Access Compliance Report

Public Rights-of-Way

Intersection ID: 47834	Main Street: ALVARADO_WY	Cross Street: CAMP_VERDE_LN	Location:	N
ADA ID: 506FAE754A1A	Ramp Type: BlendTrans2	Initial Pass/Fail: Fail	Overall Compliance: No	Severity Score: 21.25

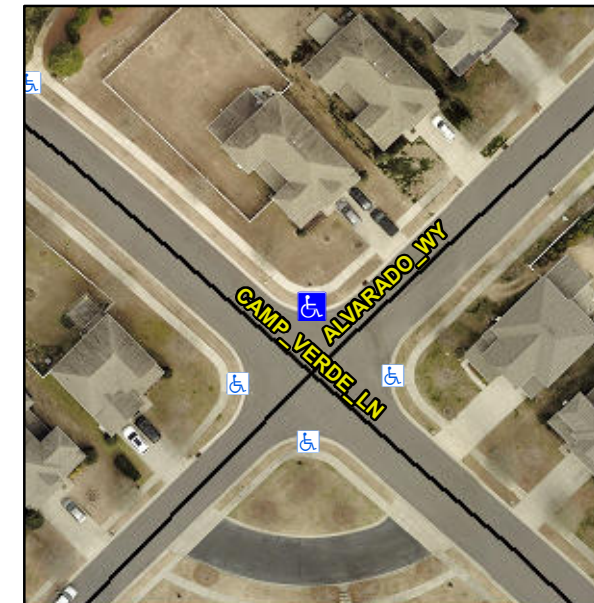
Not Found, R304.5.1, R304.5.3

Compliance	Description	Data	Compliance	Description	Data
N/A	Ramp Length (in)	135.0	Yes	BlendTrans Slope (%)	4.7
No	Ramp Width (in)	44.0	No	BlendTrans XSlope (%)	6.0
N/A	Flare Type LT	N/A	N/A	Flare Type RT	N/A
N/A	Flare Slope LT (%)	N/A	N/A	Flare Slope RT (%)	N/A
N/A	Flare Traversable LT?	N/A	N/A	Flare Traversable RT?	N/A
N/A	Landing Length (in)	N/A	N/A	DWS Provided?	N/A
N/A	Landing Width (in)	N/A	N/A	DWS Contrast?	N/A
N/A	Landing Slope (%)	N/A	N/A	DWS Length (in)	N/A
N/A	Landing X Slope (%)	N/A	N/A	DWS Full Width?	N/A
N/A	Landing Curb? (Y/N)	N/A	N/A	DWS Offset (in)	N/A
N/A	Shared Landing?	N/A			
N/A	Gutter Ponding?	N/A	N/A	Gutter Slope (%)	N/A
N/A	Gutter Lip Ht (in)	N/A	N/A	Gutter X Slope (%)	N/A
N/A	Painted X Walk1?	No	N/A	Painted X Walk2?	No
	X Walk 1 Direction	To SW		X Walk 2 Direction	To SE
	X Walk 1 Width (in)	N/A		X Walk 2 Width (in)	N/A
	X Walk 1 Slope (%)	3.1		X Walk 2 Slope (%)	2.6
	X Walk 1 X Slope (%)	3.5		X Walk 2 X Slope (%)	1.7

Remove & Replace Curb Ramp With Two New Directional Ramps or Equivalent.
